BLOOMDALE**Residency @ Genome Valley**

Details of Additions & Alterations

Flat No	316	Type	Deluxe / Semi-Deluxe
Buyer Name	H.S. Sedi		
Phone No.	8977942779	Email

Quality Control Check Report. Stage: After Brickwork (Apartments/ Lab Spaces)

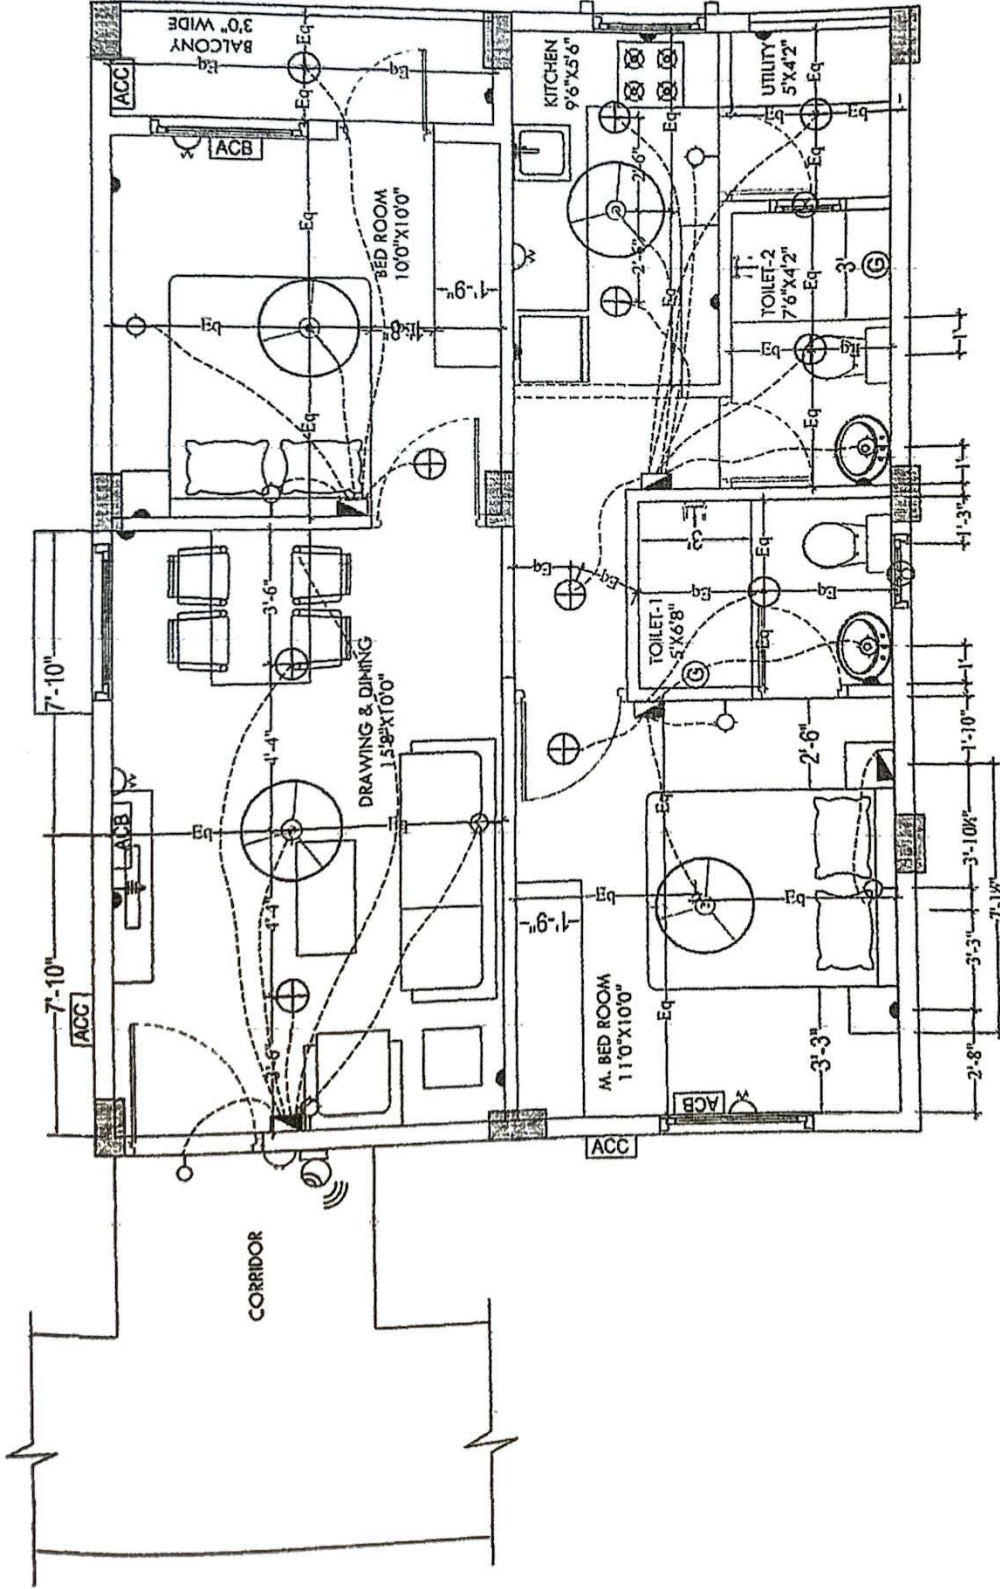
① In Kitchen 15 Amp to be provide ~~where~~ switch plate on tile.

Description	Direction	Owners & Developers :		Date :	Promoted by	
		Modi Realty Genome Valley LLP		Prepared By :	06.09.2021	Modi Properties Pvt Ltd
		Project Name & Phase :		Approved By :	Imran	
		BRGV		Scale :	Soham Modi	
First Floor Typical Flat - 114,116,118,120	N 				N.T.S	Phone:+91-40-66335551

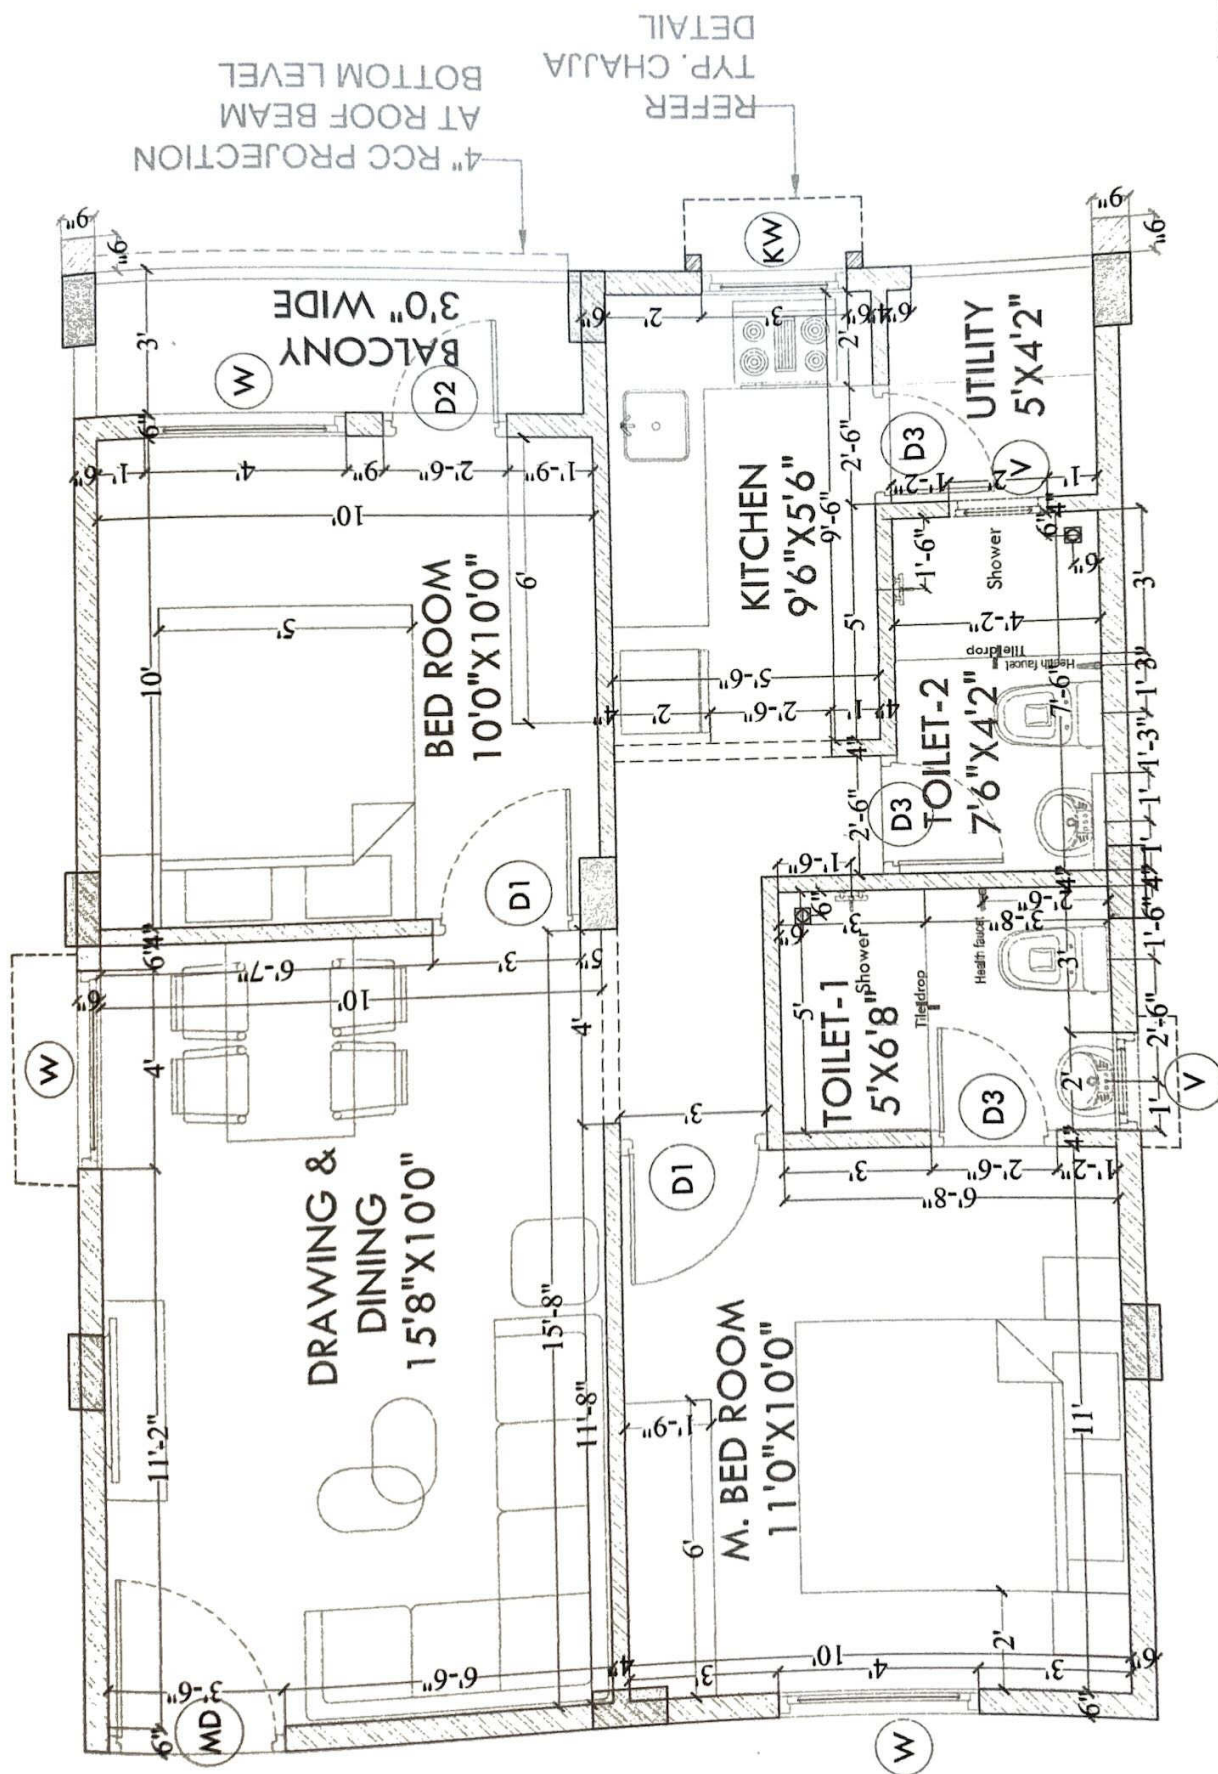
only RCC Slab as per Model flat 121.
With Granite.
